**Goetz Road and Newport Road
Completion of Improvements**

ISSUED BY ADDENDUM No. 2
ATTACHMENT "A", Page 1 of 4

Project No. B8-0643

RETAINING WALL DETAILS No. 1

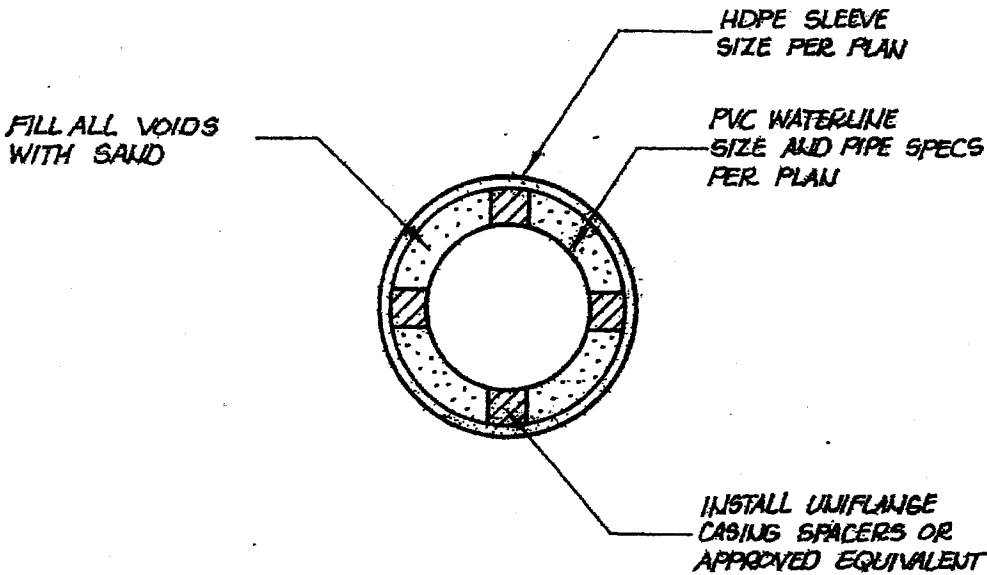
- Retaining (Scour) Wall – Caltrans Standard Plan B0-3.
- Retaining (Scour) Wall – Caltrans Standard Plan B3-1
- Retaining (Scour) Wall – Caltrans Standard Plan B3-8

Item 13: **Retaining (Scour) Wall Plans.**

Retaining (Scour) Wall Plans are provided and made part hereof.
For grading and scour rip rap see sheet 13A issued with this addendum 2, item 9 below.
